Re: Indian Point Unit 3
Docket No. 50-286
NL-05-010

**Subject: Reply to RAI regarding Indian Point Unit 3 Relaxation Requests
for Inspection of Reactor Pressure Vessel Head per NRC First Revised
Order, EA-03-009 (TAC No. MB3195)**

**REPLY TO NRC REQUEST FOR ADDITIONAL INFORMATION
REGARDING RELAXATION REQUESTS FOR INSPECTION
OF IP3 REACTOR PRESSURE VESSEL HEAD**

**ENTERGY NUCLEAR OPERATIONS, INC.
INDIAN POINT NUCLEAR GENERATING UNIT NO. 3
DOCKET NO. 50-286**

FIGURE 1
ID3 - PENETRATION NOZZLES
NOS. 74 THROUGH 78 (TYP.)

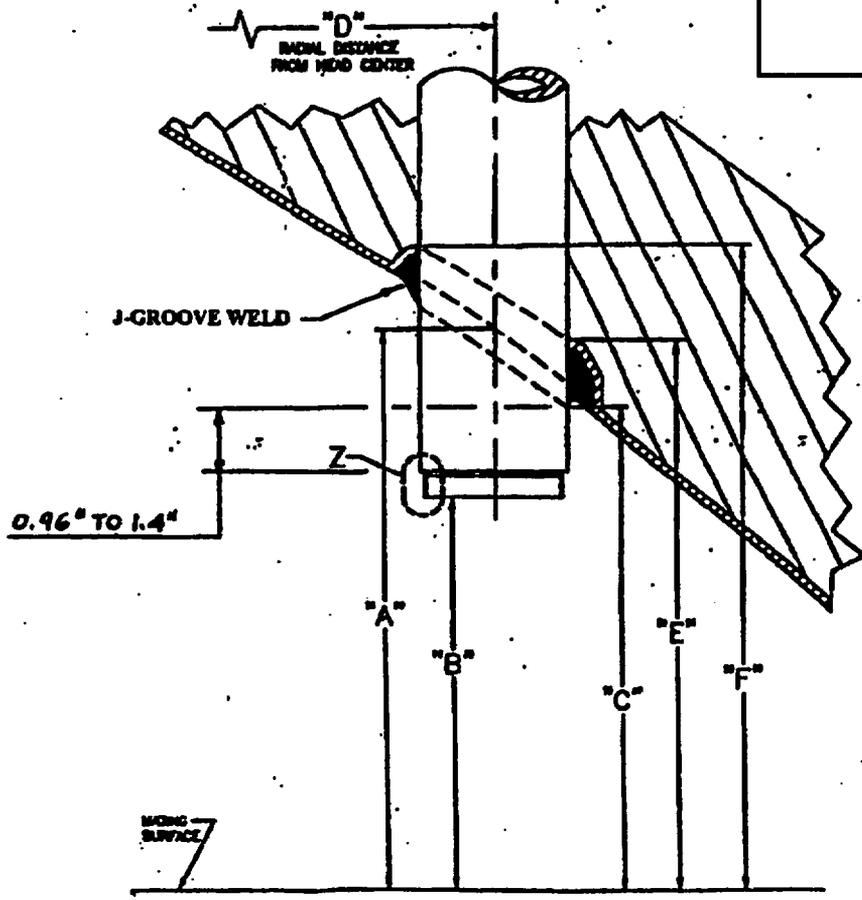
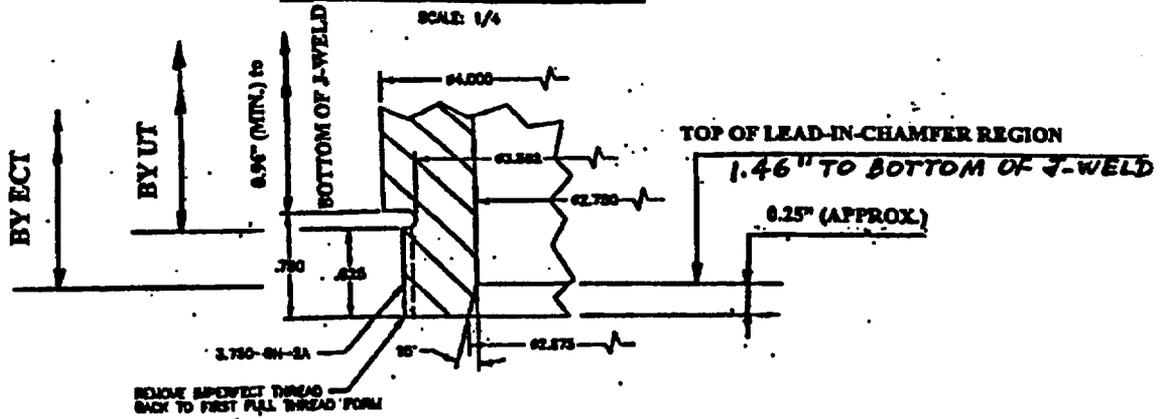
Provide a summary of the crack growth calculation describing the methodology used, including the input assumptions and results. Discuss whether the crack growth rates assessed were based on the equations in MRP-55 and whether the crack growth evaluation was based on the as-built weld geometry.

The First Revised Order allows either ultrasonic testing (UT) examination or a surface examination (i.e. liquid penetrant or eddy current) to be performed. Discuss why a surface examination is not being considered for the threaded area of the five penetration nozzles identified. A surface examination would provide meaningful results on the threaded regions. Discuss any hardships that would be imposed by performing the surface examination (dose, safety risks etc.).

A crack growth evaluation was performed using the methods of MRP-55 for crack growth caused by primary water stress corrosion cracking at a head temperature of 592 degrees F. The nozzle is an open-ended tube so that the operating pressure and temperature are essentially the same at both the inside and outside surface of the tube. For purposes of this analysis, a conservatively high hoop stress of 30 ksi was assumed, as compared to the calculated stresses of less than 20 ksi as noted above (Reference 5, First Revised Order EA-03-009, page 10). An initial hypothetical flaw is assumed to exist with a worst-case orientation (axial) and flaw growth occurs in a single direction toward the J-groove weld. Because the location of the hypothetical flaw is in the threaded region, at least 0.96 inches from the J-groove weld, the weld residual stresses are also negligible. The evaluation confirmed that the hypothetical flaw would not grow to the J-groove weld over at least 4 years of operation. The weld geometry dimensions are taken from the IP3 plant specific drawing (IP3V-0439-1680) entitled: "Indian Point Unit 3, RVH Penetration Inspection, Interface Dimensions". Refer to the attached Figure 1 for the location of these dimensions on the penetration nozzles.

The inspection methods and results performed during Refueling Outage 3R12 in April 2003 were submitted in Entergy's letter to NRC, NL-03-098, dated June 12, 2003. The non-visual NDE portion of the examination for the referenced five penetration nozzles was performed using a single probe assembly that contained a pair of transducers for the UT examination and an eddy current coil for the ECT surface examination. The axial coverage with this probe assembly extended down to approximately 0.75 inches from the bottom of the nozzle (for the UT exam) and down to approximately 0.25 inches from the bottom of the nozzle (for the ECT surface exam). Meaningful UT data below approximately 0.75 inches was limited by signal dispersion in the threaded region. Meaningful ECT data below approximately 0.25 inches was also limited

because the eddy current coil tends to lose contact with the examination surface as it reaches the lead-in chamfer region (see attached Figure 1). As discussed in the response to Question 3a above, the hardships in removing the guide funnels welded to the bottom of the nozzles precludes examination of the OD wetted surface areas of the nozzle tubes.
